Access Compliance Report Public Rights-of-Way (Curb Ramps)

Intersection ID: 22317 Main Street: SHARON RD **Cross Street: SHARON ACRES RD** Location: S ADA ID: 410531D1C442 Ramp Type: PerpDiag Initial Pass/Fail: Fail **Overall Compliance: No Severity Score:** 12.5

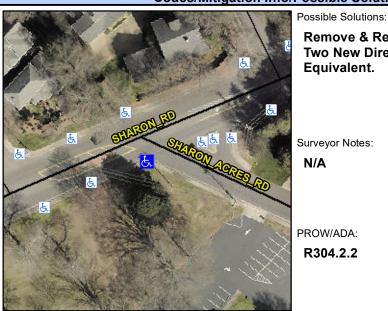
R304.2.2

Data	Compliance Description		Data
N/A	Ramp Length (in)	48.0	No	Ramp Slope (%)	11.0
Yes	Ramp Width (in)	48.0	Yes	Ramp XSlope (%)	2.0
N/A	Flare Type LT	N/A	N/A	Flare Type RT	N/A
N/A	Flare Slope LT (%)	N/A	N/A	Flare Slope RT (%)	N/A
N/A	Flare Traversable LT?	N/A	N/A	Flare Traversable RT?	N/A
N/A	Landing Length (in)	N/A	N/A	DWS Provided?	N/A
N/A	Landing Width (in)	N/A	N/A	DWS Contrast?	N/A
N/A	Landing Slope (%)	N/A	N/A	DWS Length (in)	N/A
N/A	Landing X Slope (%)	N/A	N/A	DWS Full Width?	N/A
N/A	Landing Curb? (Y/N)	N/A	N/A	DWS Offset (in)	N/A
N/A	Shared Landing?	N/A			
N/A	Gutter Ponding?	N/A	N/A	Gutter Slope (%)	N/A
N/A	Gutter Lip Ht (in)	N/A	N/A	Gutter X Slope (%)	N/A
N/A	Painted X Walk1?	No	N/A	Painted X Walk2?	No
	X Walk 1 Direction	To E		X Walk 2 Direction	To N
N/A	X Walk 1 Width (in)	N/A	N/A	X Walk 2 Width (in)	N/A
	X Walk 1 Slope (%)	2.8		X Walk 2 Slope (%)	3.1
	X Walk 1 X Slope (%)	2.3		X Walk 2 X Slope (%)	3.9

Remove & Replace Curb Ramp With Two New Directional Ramps or Equivalent.
